**CITY OF LA VISTA**  
**MAYOR AND CITY COUNCIL REPORT**  
**APRIL 15, 2014 AGENDA**

<b>Subject:</b>	<b>Type:</b>	<b>Submitted By:</b>
APPLICATION FOR PRELIMINARY PUD, LOTS 1 & 2, SOUTHPORT EAST REPLAT 4, AND LOTS 1 & 2, SOUTHPORT EAST REPLAT 10 (NW OF PORT GRACE & EASTPORT PKWY.)	◆ RESOLUTION ORDINANCE RECEIVE/FILE	ANN BIRCH COMMUNITY DEVELOPMENT DIRECTOR

RE: Preliminary PUD, Preliminary Plat, Final Plat -Initial Review  
Southport East Replat Thirteen

RE: Preliminary PUD, Preliminary Plat, Final Plat -Initial Review  
Southport East Replat Thirteen

PLANNED UNIT DEVELOPMENT  
EMERGENCY VEHICLE EXHIBIT

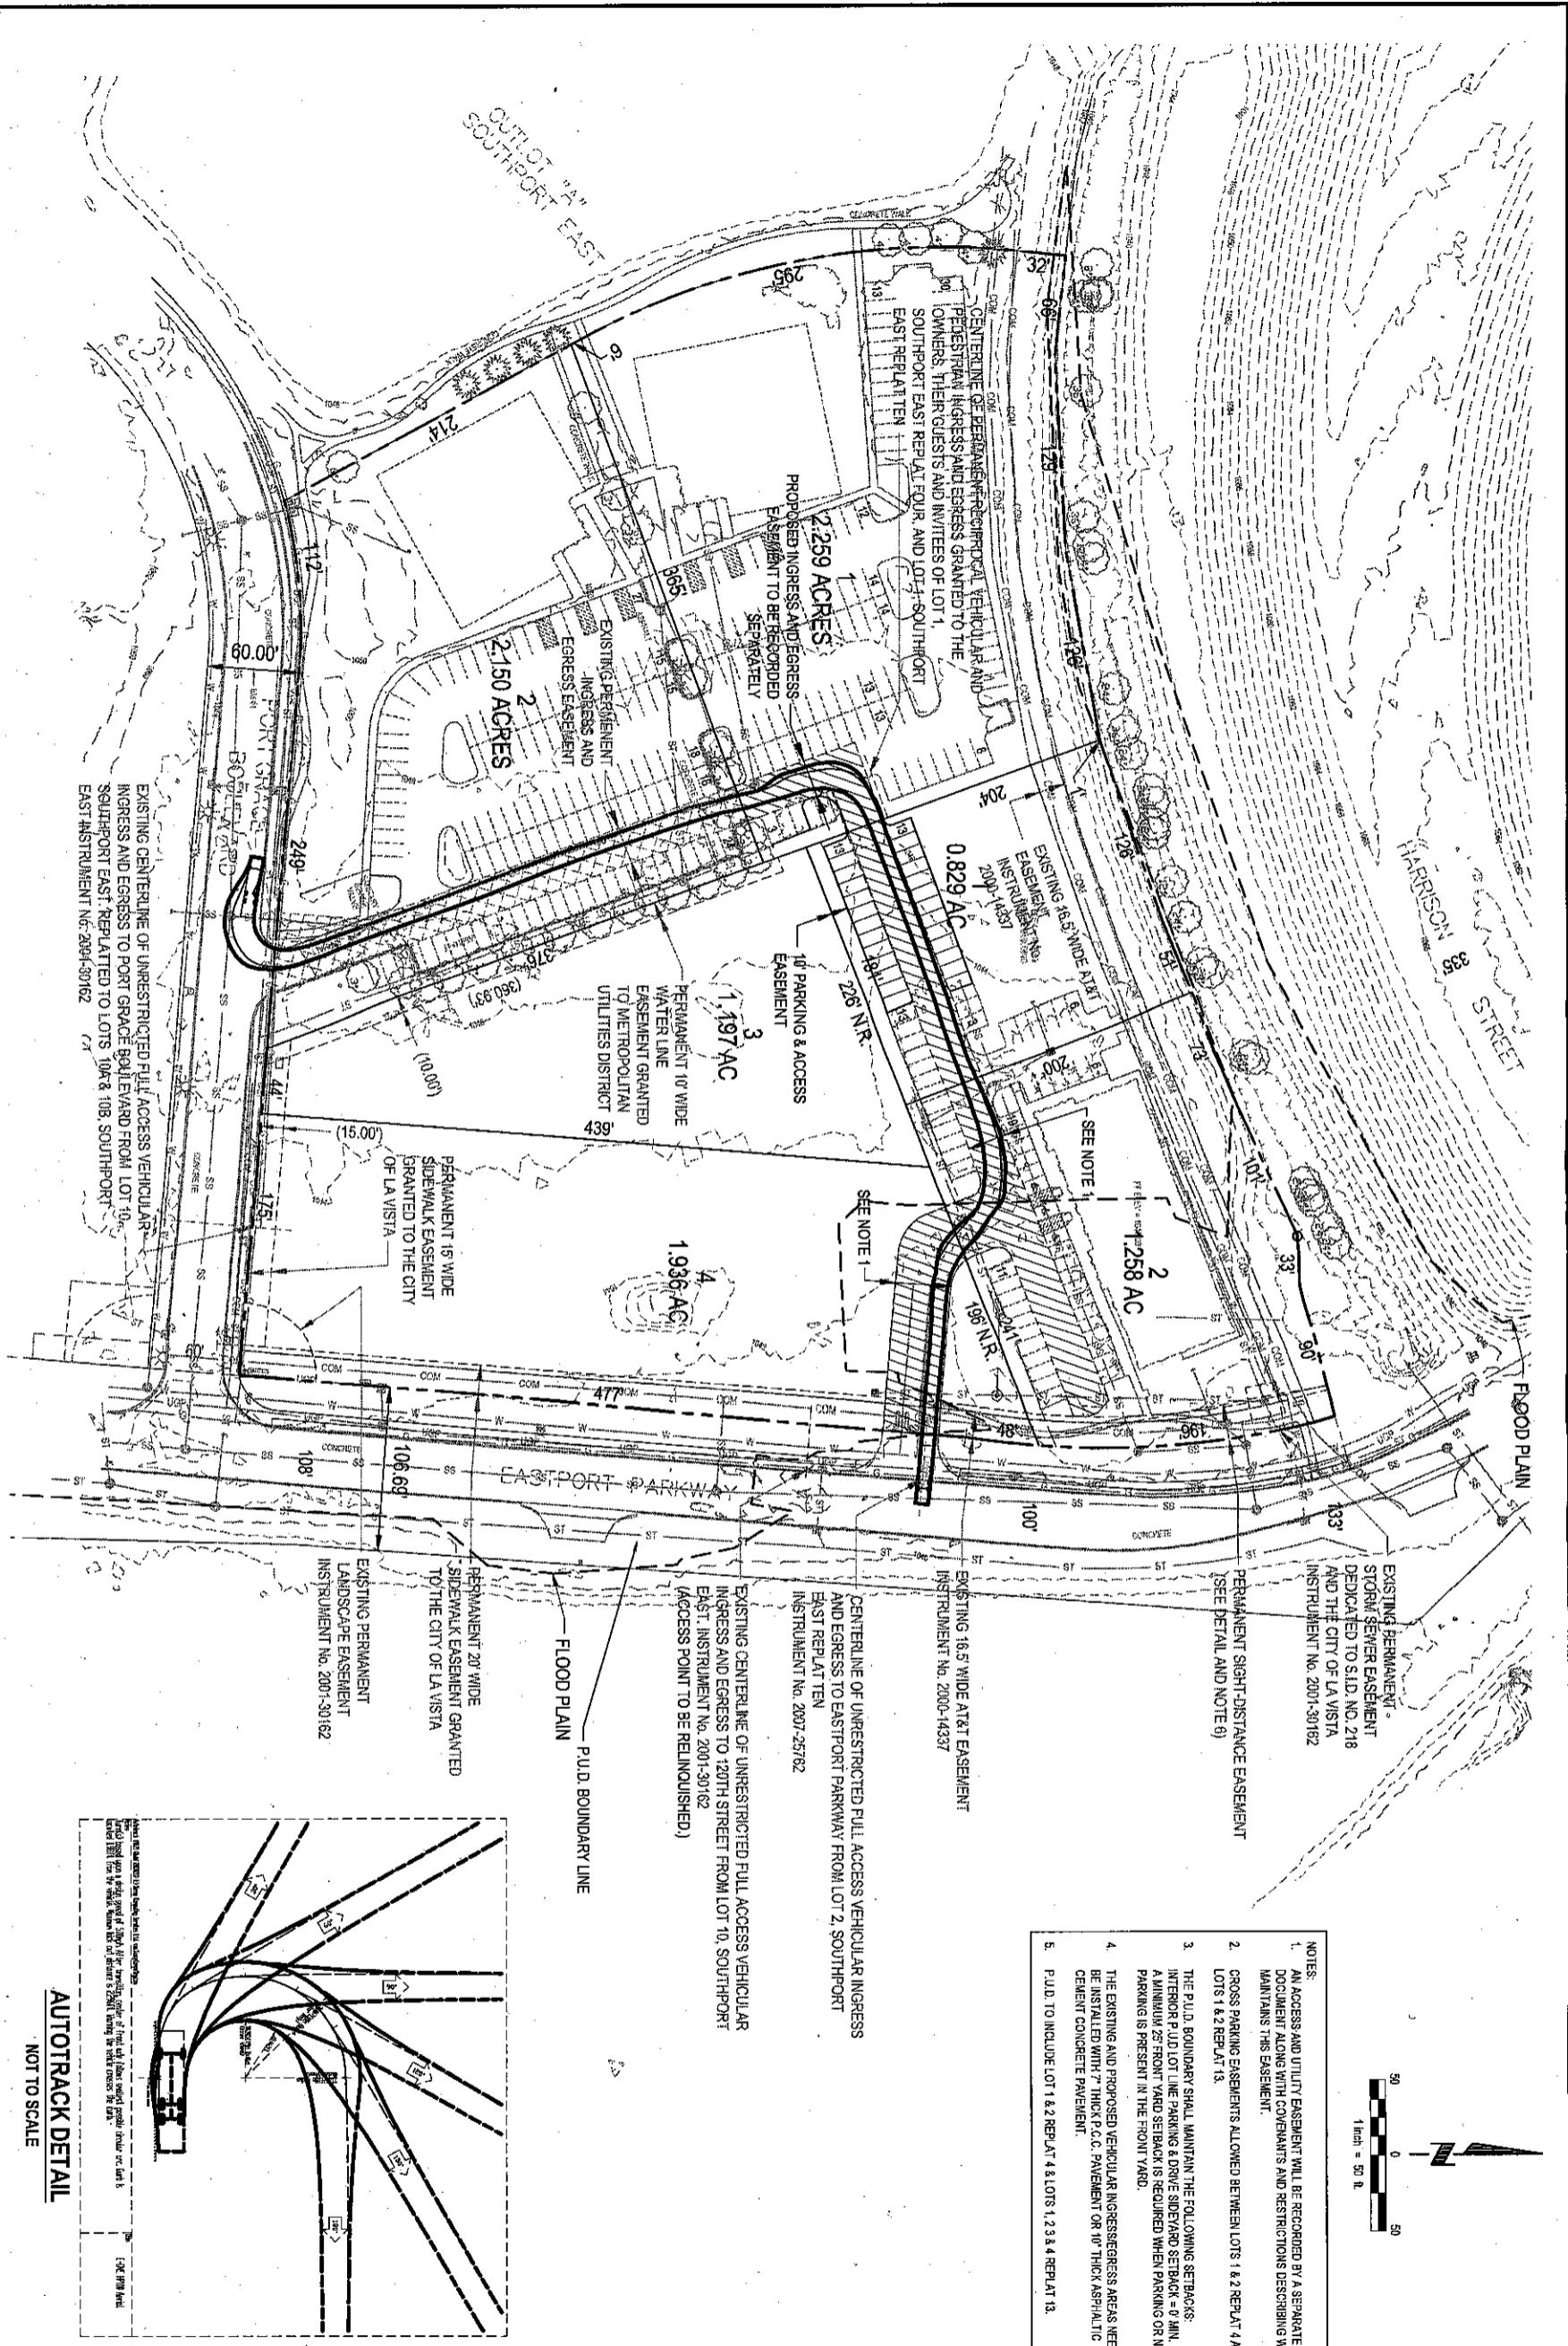
11. There needs to be a preliminary PUD plan showing existing and proposed sanitary sewer and storm sewers.
12. A legible copy of the detail of the emergency vehicle being used on the Emergency Vehicle Exhibit to identify the vehicular path through the site

needs to be provided. Also need to have "Note 1" provided which is referenced on the plan but not set forth.
